STAFF REPORT

Site Plan & Architectural Review

LOCATION: 488 Dunn Street, Coos Bay, Oregon
T. 25S, R. 13W, S. 21CB, Tax Lot 2900

SUBJECT: Site Plan and Architectural Review (SPAR) #187-ZON15- 52
Establishment of a one story 4,200 square foot storage building

SITE PLAN / UTILITIES PLAN
1"=10'

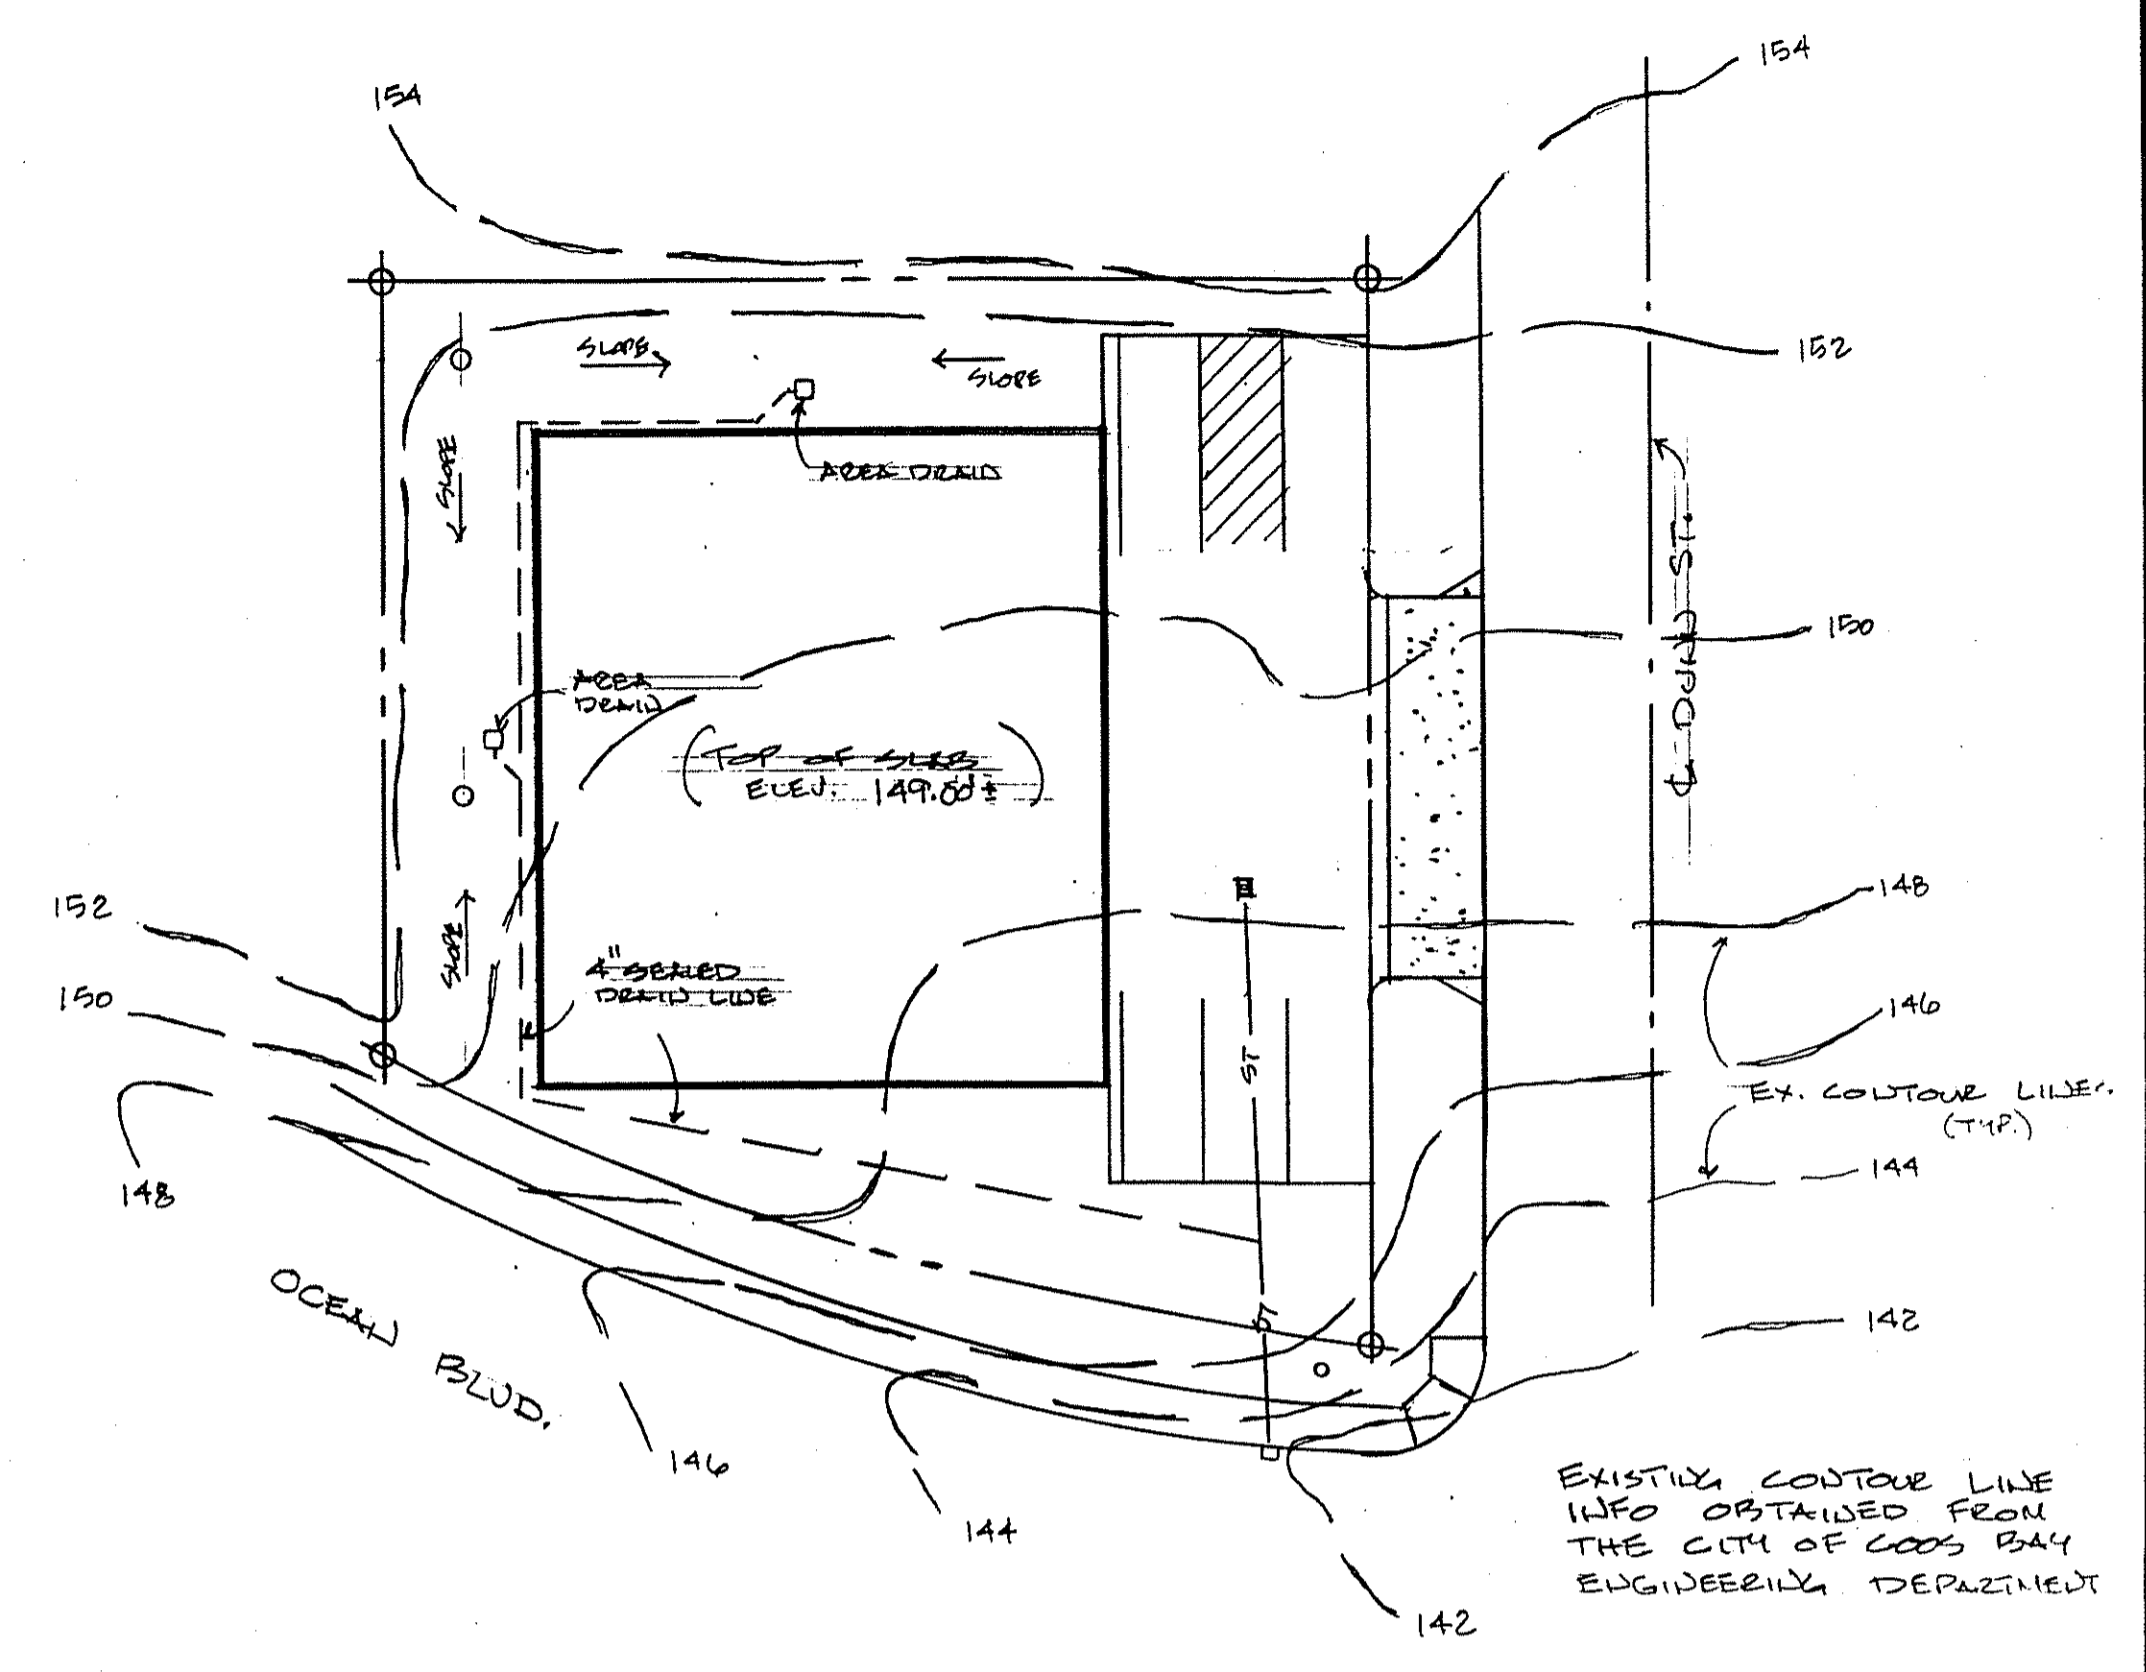
- 2a. The applicant's submittal indicates an existing 8" sanitary sewer line is currently crossing through the center of the project site. Two options are proposed to address this issue.

Option No. 1 proposes to re-route this line to the North and West sides of the proposed building pad within a newly proposed 15' wide easement.

Option No. 2 proposes to replace the portion of the line that will lie beneath the new structure with an upgraded assembly. Both options need to be performed in accordance with the requirements of the Coos Bay Public Works Department and the Oregon State Plumbing Division. A permit will be required for this specific work.

Staff strongly recommends realignment of the line so that it is aligned around (rather than under) the proposed structure, with required easements and possible cost sharing with the City. Having a sanitary sewer line under a structure is not recommended and it would appear to be a risky encumbrance on the property. The property owner is advised that the person that approved this condition in 2008 was not a licensed engineer and the City assumes no responsibility should a failure of the pipe occur or damage to the building occur as a result of the sanitary sewer alignment.

Sanitary Sewer: This project has an 8 inch public sewer line that bisects the property. The project is proposing two options at the owner's expense. **Option 1** is to reroute the sewer such that it is not aligned under the proposed building. **Option 2** is to replace the existing sewer in the same alignment. The City strongly encourages the owner to coordinate with the City to pursue **Option 1**. The City can work with the owner regarding cost sharing and deviations from easement width requirements.

Sanitary Sewer: This project has an 8 inch public sewer line that bisects the property. The project is proposing two options at the owner's expense. Option 1 is to reroute the sewer such that it is not aligned under the proposed building. Option 2 is to replace the existing sewer in the same alignment. The City strongly encourages the owner to coordinate with the City to pursue Option 1. The City can work with the owner regarding cost sharing and deviations from easement width requirements.

Conditions of Approval for Option 1:

1. Unless otherwise requested and approved, the utility easement requirement will be as follows: The minimum easement width for installations of storm and sewer with depths of cover of 5-feet or less (measured at the top of pipe) is 15 feet. For each additional 5-feet of cover over 5-feet (rounded up), the minimum easement width will be increased by 10-feet. Easements shall be centered over the utility.

2. If the proposed tie in to the manhole is not at flow line, an inside drop manhole will be required.
3. Detailed plans and specifications, prepared by a licensed professional, for the sewer realignment shall be submitted and approved prior to issuance of building permits.

4. All improvements must be in accordance with local and State requirements/standards.
5. Owner shall certify a utility easement, prepared by the City for the sewer realignment. This document must be recorded prior to issuance of building permits and applicant is responsible for recording fees.

Condition of approval for Option 2:

1. Sewer replacement must extend a minimum 5 feet beyond either side of the proposed building.
2. All improvements must be in accordance with local and State requirements/standards.
3. Must obtain the approval from the State Plumbing official prior to issuance of building permits.

4. Detailed plans and specifications, prepared by a licensed professional, for sewer realignment shall be submitted and approved prior to issuance of building permits.
5. Owner shall certify a declaration of real covenant/easement, prepared by the City that defines that the property owner is responsible for any damage to the proposed structure or public sewer that is aligned under the structure. This document must be recorded prior to issuance of building permits and applicant is responsible for recording fees.
6. Replaced pipe shall be encased in a cast iron pipe and a manhole shall be installed on the property west of the proposed structure to ensure maintenance at both the downstream and upstream limits.

2. ***Relocation of the sanitary sewer line Option No.1:***
 - a. ***Unless otherwise requested and approved, the utility easement requirement will be as follows: The minimum easement width for installations of storm and sewer with depths of cover of 5-feet or less (measured at the top of pipe) is 15 feet. For each additional 5-feet of cover over 5-feet (rounded up), the minimum easement width will be increased by 10-feet. Easements shall be centered over the utility;***

- b. ***If the proposed tie in to the manhole is not at flow line, an inside drop manhole will be required;***
 - c. ***Detailed plans and specifications, prepared by a licensed professional, for the sewer realignment shall be submitted and approved prior to issuance of building permits;***

- d. ***All improvements must be in accordance with local and State requirements/standards; and,***
 - e. ***Owner shall certify a utility easement, prepared by the City for the sewer realignment. This document must be recorded prior to issuance of building permits and applicant is responsible for recording fees.***

SITE GRADING PLAN
1"=20'

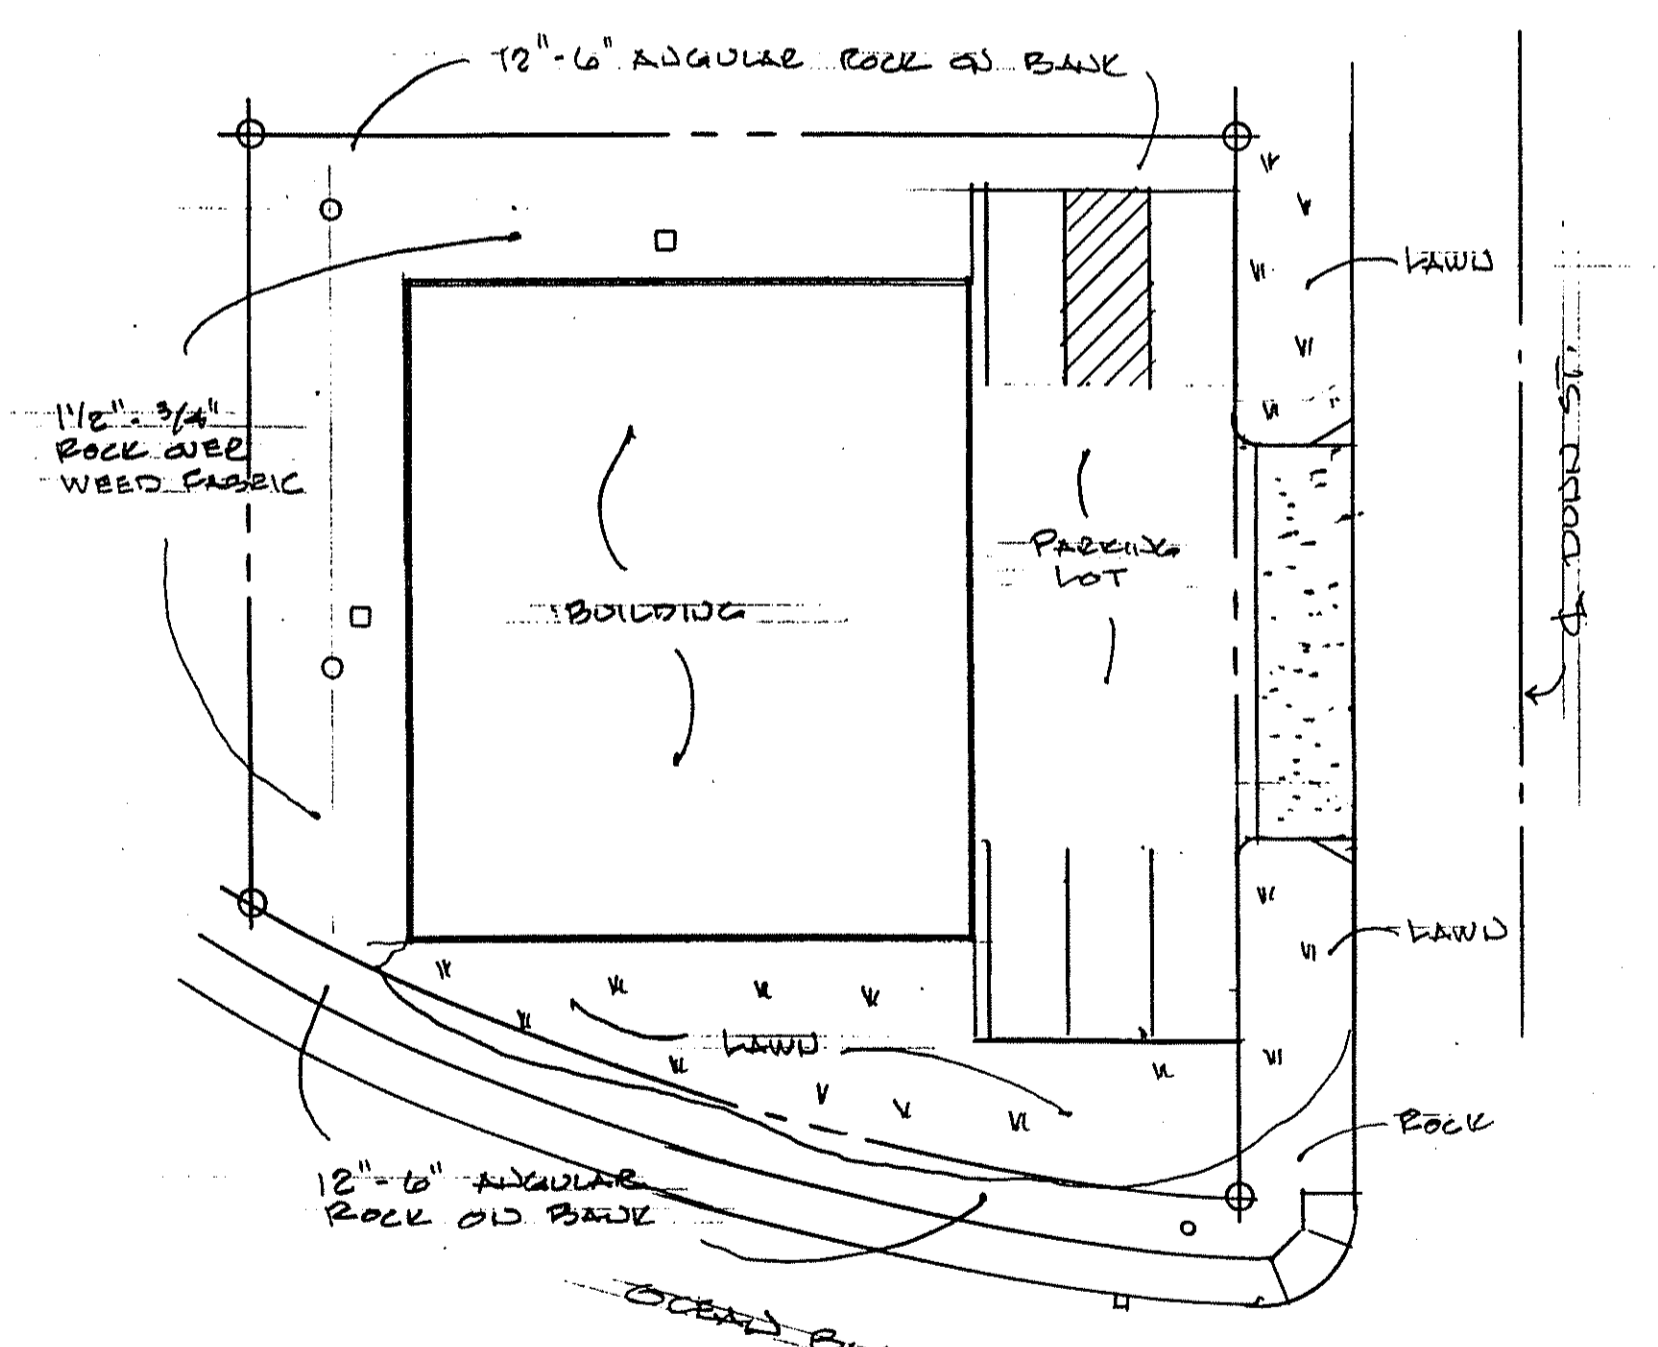
- 3b. As per the City Engineering Department, based on the information submitted, the site is proposing to increase the impervious area and add a connection at Ocean Boulevard. It does not appear that the project is proposing any measures for storm water quality and/or quantity. If project is proposing a new connection or the replacement of the existing connection to the storm sewer system it must be in conformance with both local and state requirements. Prior to approval of building permits project must submit information that the increased runoff from the project will not adversely impact storm drain system. (*See Attachment G - CB Engineering Comments*).

Storm Sewer: Based on the information submitted, the site is proposing to increase the impervious area and add a connection at Ocean Boulevard. It does not appear that the project is proposing any measures for storm water quality and/or quantity. If project is proposing a new connection or the replacement of the existing connection to the storm sewer system it must be in conformance with both local and state requirements. Prior to approval of building permits project must submit information that the increased runoff from the project will not adversely impact storm drain system. A (storm) sewer connection permit must be approved prior to connection to storm sewer. Permit must provide plans and specifications for storm sewer connection.

City Comment: Based on the information submitted, the site is proposing to increase the impervious area and add a connection at Ocean Boulevard. It does not appear that the project is proposing any measures for stormwater quality and/or quantity. If project is proposing a new connection or the replacement of the existing connection to the storm sewer system it must be in conformance with both local and state requirements. Prior to approval of

CONDITIONS: If proposing a new connection or the replacement of the existing connection to the storm sewer system, such connection must be in conformance with both local and state requirements and prior to approval of building permits applicant must submit information indicating that the increased runoff from the project will not adversely impact storm drain system.

5. ***If project is proposing a new connection or the replacement of the existing connection to the storm sewer system, such connection must be in conformance with both local and state requirements and prior to approval of building permits applicant must submit information indicating that the increased runoff from the project will not adversely impact storm drain system.***
